# SOMERVELL FAMILY DOLLAR

GLEN ROSE, TX

# Permit to Construct Access Driveway Facilities on Highway Right of Way

**From:** Sarah Horner  
**Sent:** Wednesday, February 15, 2023 9:24 AM  
**To:** Noel Spaar; Michael Millsap  
**Cc:** Anthony Bruce  
**Subject:** Family Dollar Glen Rose - SH 144 Driveway Permit Request

# PROPOSED DRIVEWAY

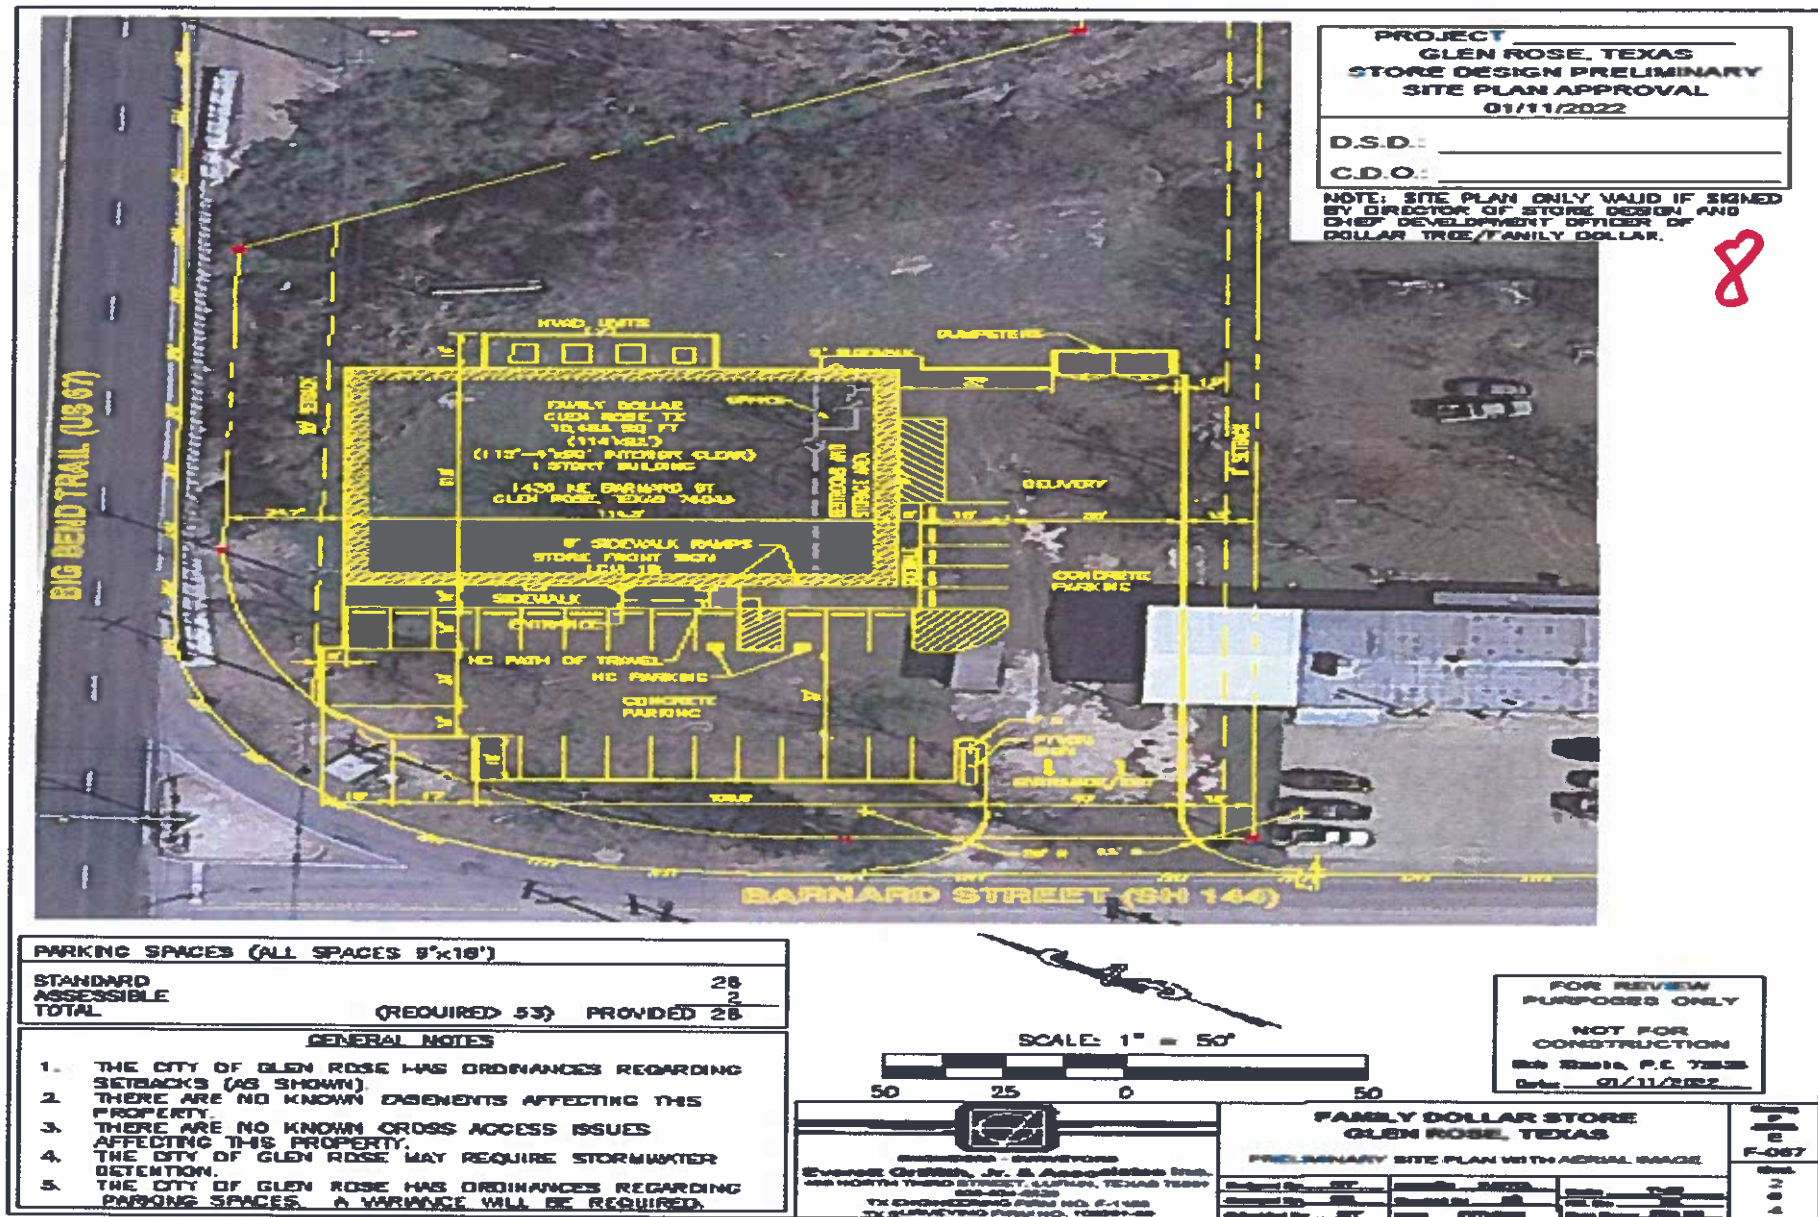
One comment I have regarding the TIA: The comment about spacing mentions they can't meet the required 250' distance from the intersection and retain access to the property. However, the property is currently owned by one landowner who also owns the adjacent Green's Auto Shop.

So if Family Dollar would purchase the entire property, then they could meet the required distance for this proposed driveway.

However, we noted the distance of 63 ft incorrectly. It is 168' as the TIA review memo states.

I measured to the beginning of the ramp just as if it was a driveway, and it will measure 63'. I have turned this site down due to the safety issues that will arise as a vehicle traveling West on U.S.67 turns right onto SH 144 & then wants to make a left turn into the family dollar driveway and has to stop due traffic traveling south on SH 144. you will have several rear end collisions.

If they purchased all the property, then they can move the driveway entrance south.

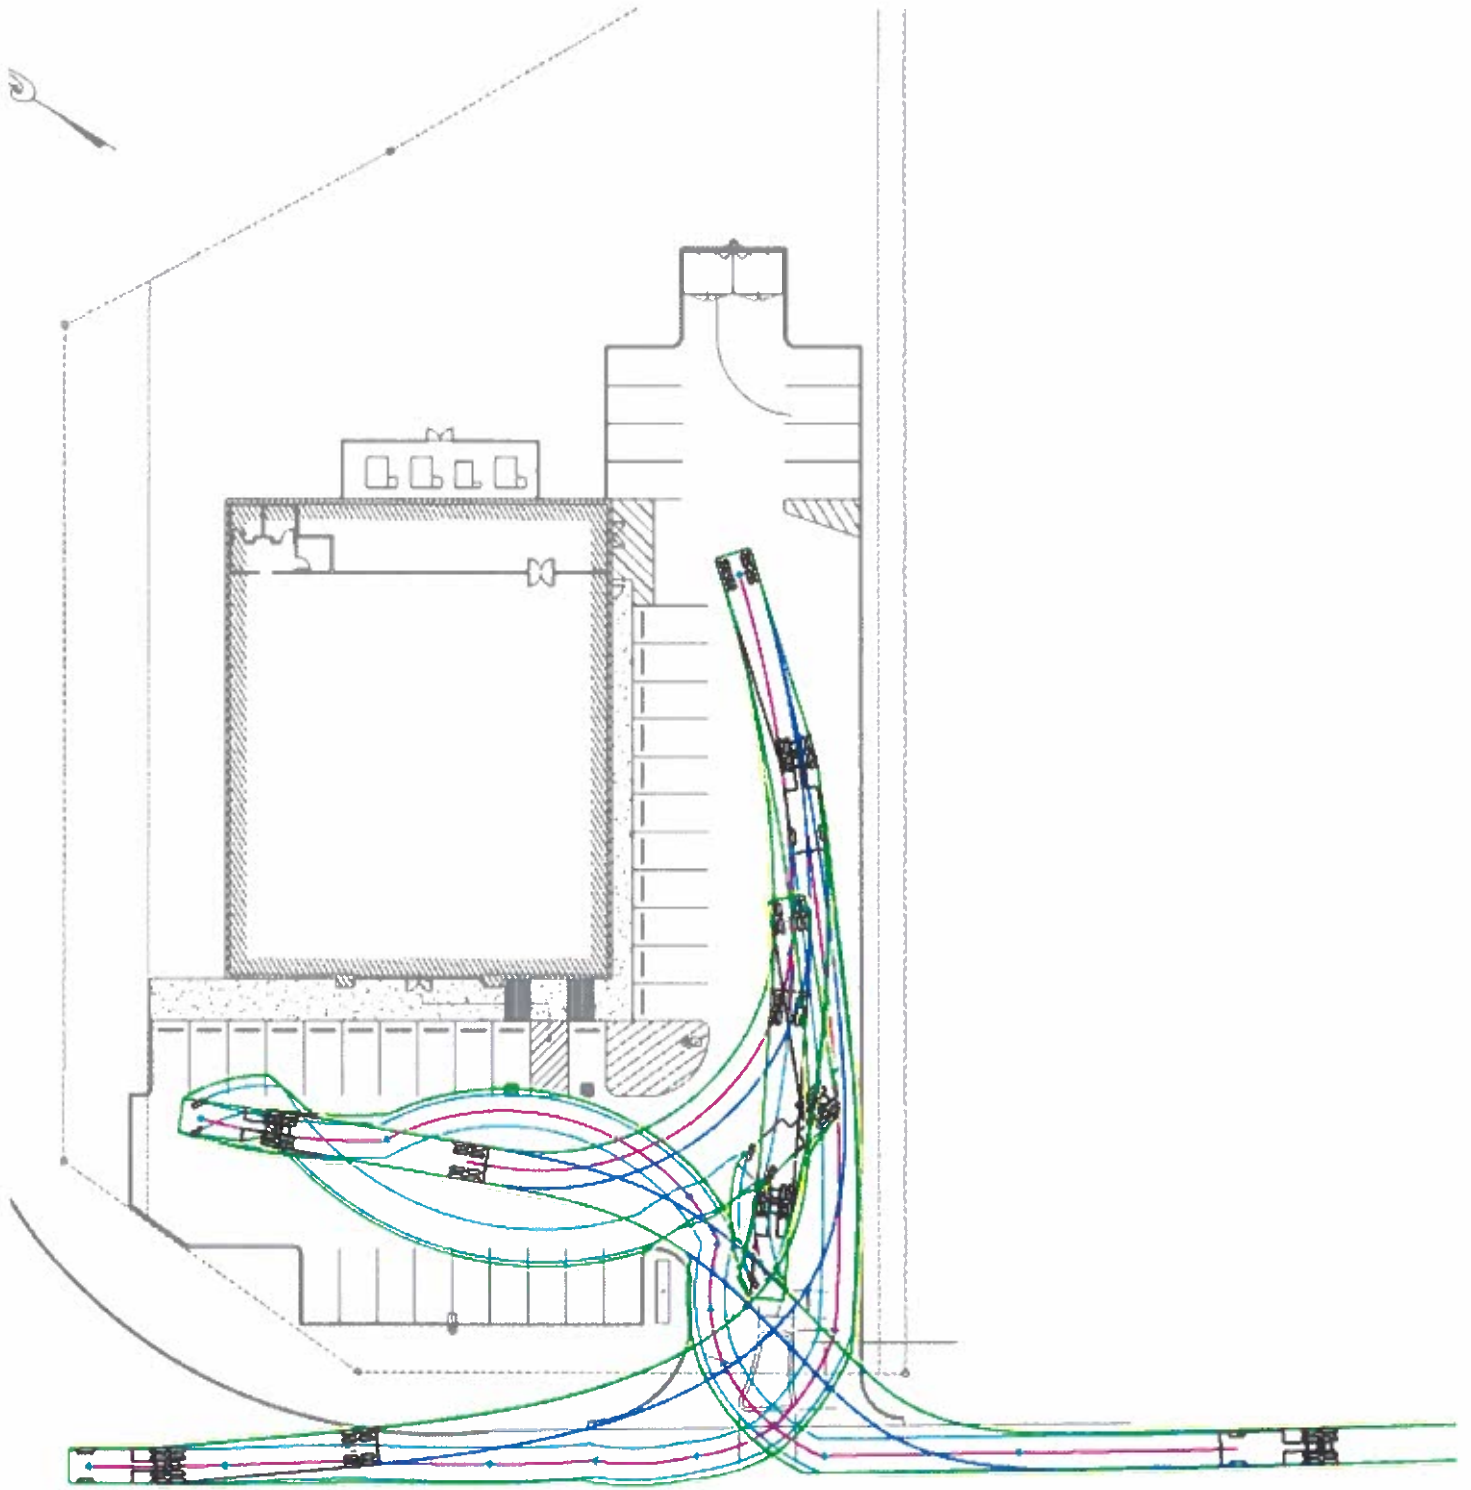
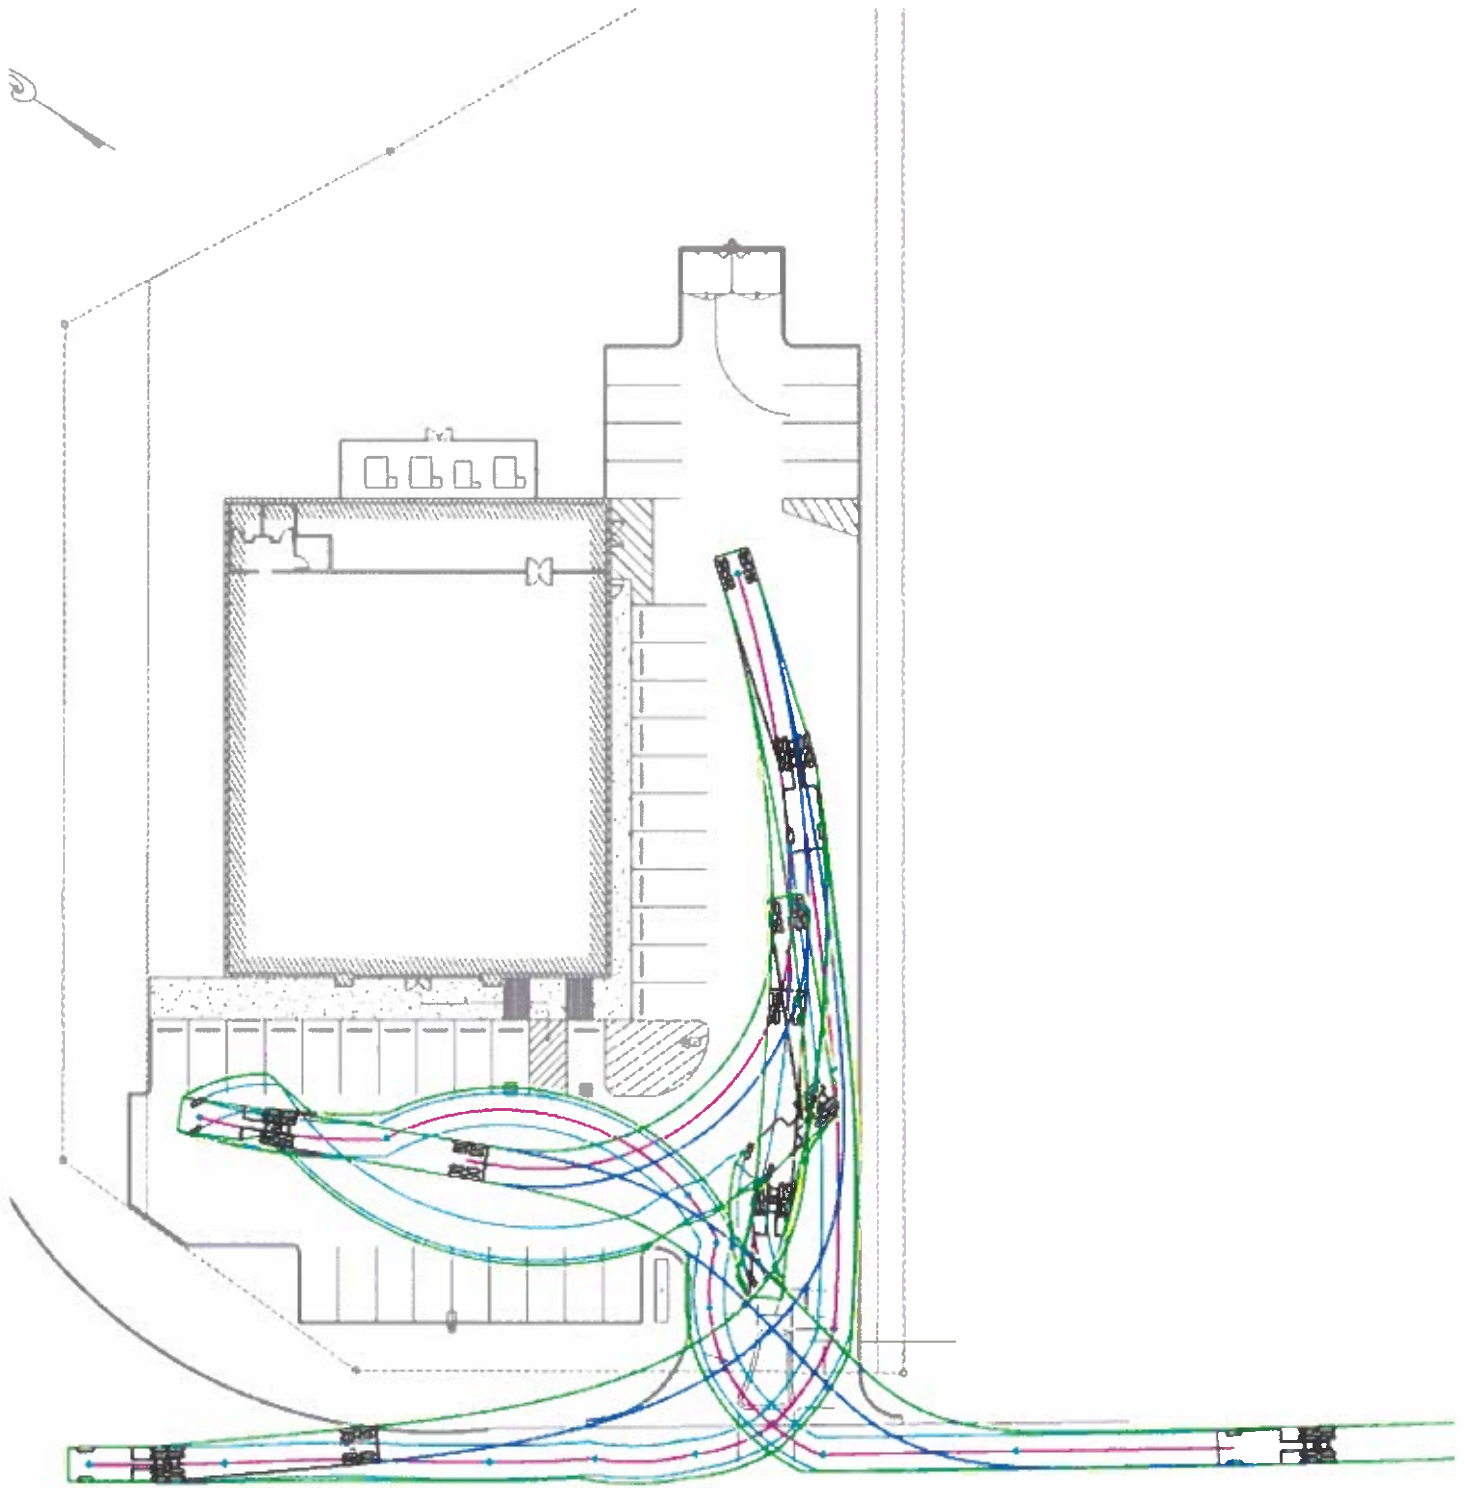
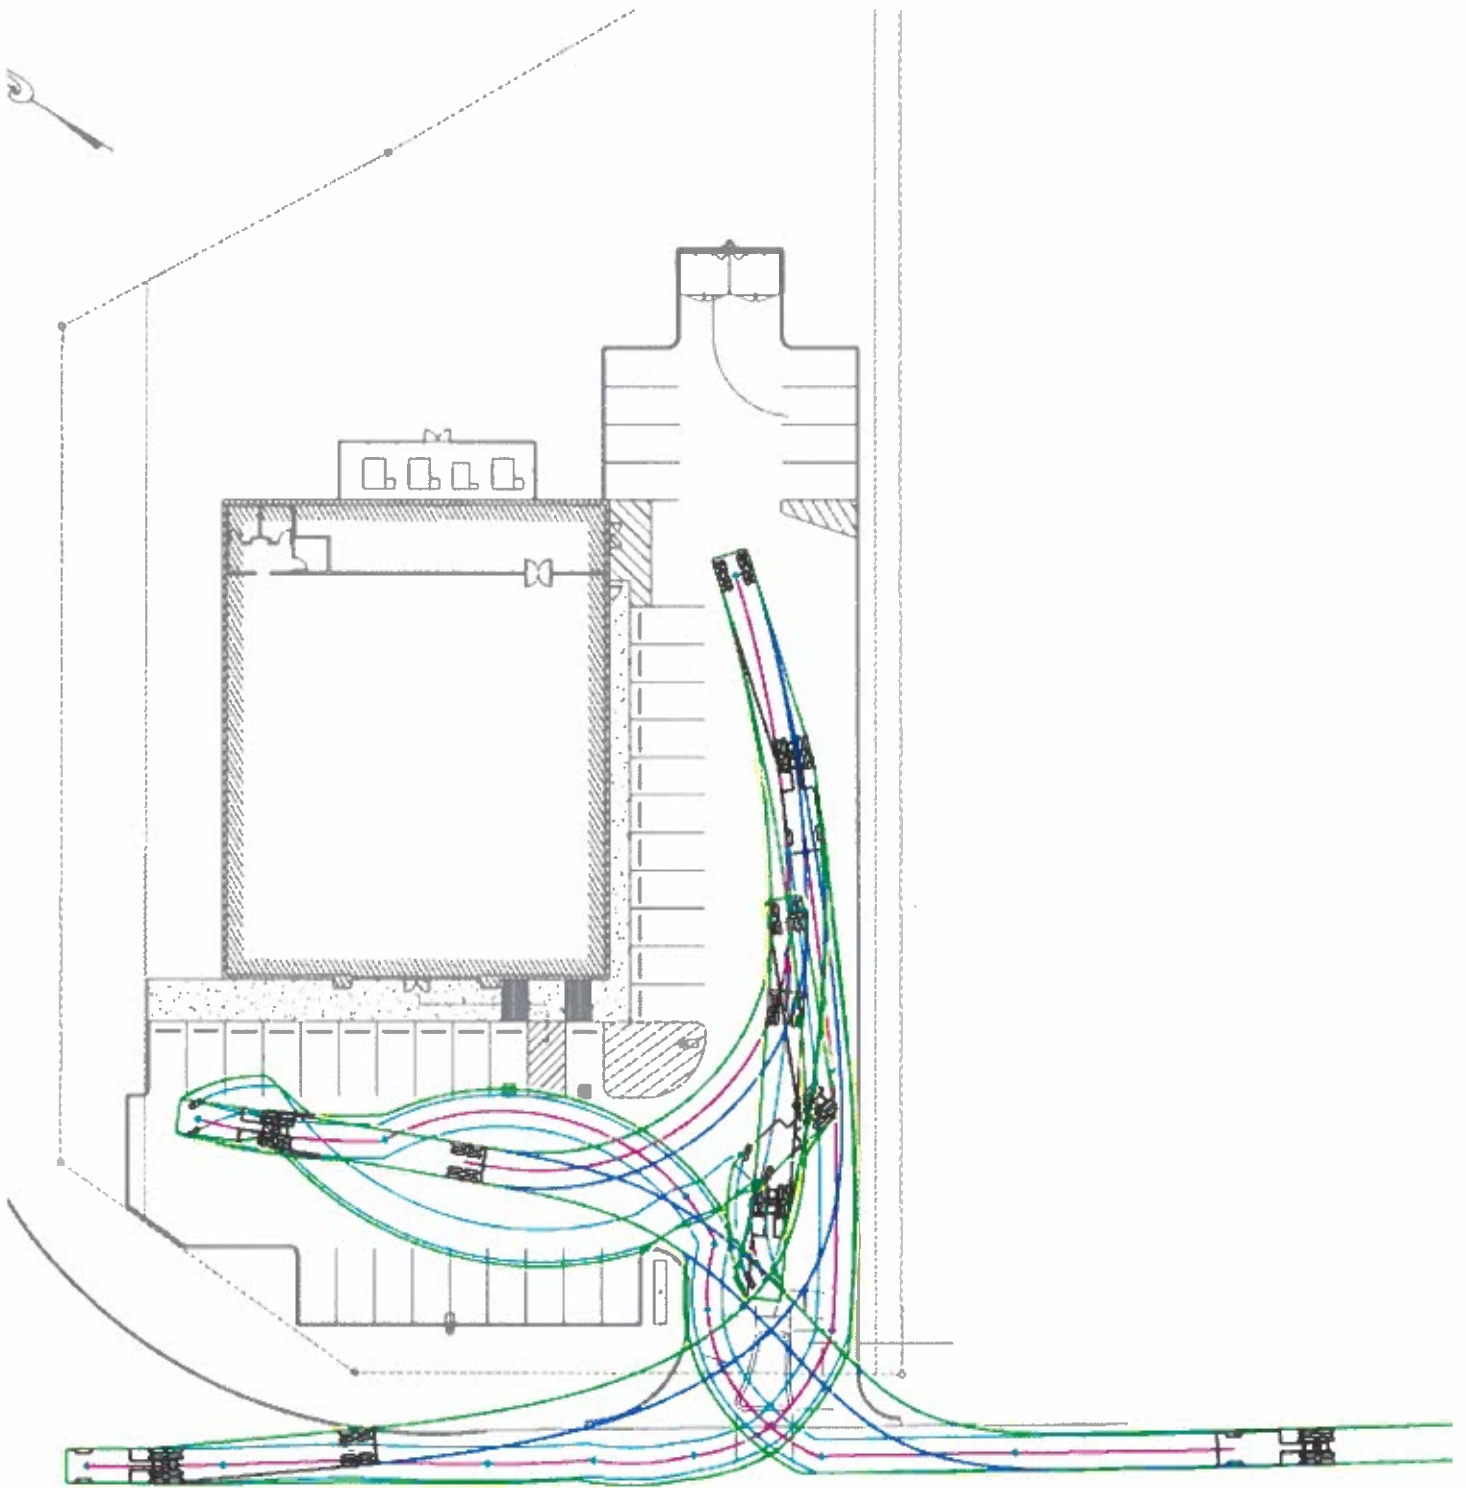
Tony,  
The moment that is shown in the test is the exact moment we are trying to restrict. Please revise with the truck turning right into the parking lot and exiting by turning right as well.  
Thank you,  
-Noel Spaar

Tony,  
This driveway design does not appear to discourage left turns into the parking lot.

If the trucks will have to turn left into the parking lot then how would they gain access if the center median was to be installed?

This is the WB-67 truck coming in from the south and departing to the north towards US 67 (right-in/right-out) from SH 144.

The turns are really tight and the truck will off-track without using some of the southbound pavement.

We've been working on concept for restricting access at their proposed driveway on SH 144. I've put together a porkchop type of configuration for the driveway on SH 144 (see attached), and we couldn't fit in a porkchop curb that presents as a definite restriction for left turns while being able to get the WB-67 truck in and out of the site. That truck path sweeps the entire driveway and would have to mount the median curb for access.

Noel,  
That's the issue – any hard curbs that we install may cause issues with a truck turn in/out. That's why I couldn't see doing the porkchop profile with the curb slanting down on the face parallel to SH 144. It might be able to be mountable (about 3" tall), but a hard face and curb is really going to be difficult with the truck turns. If there is a median down the middle of SH 144 then it is likely the truck would pop the curb or off-track/off-pavement to better make the turn on-pavement. I think just about anything that would be done would have to be mountable (porkchop or median divider).
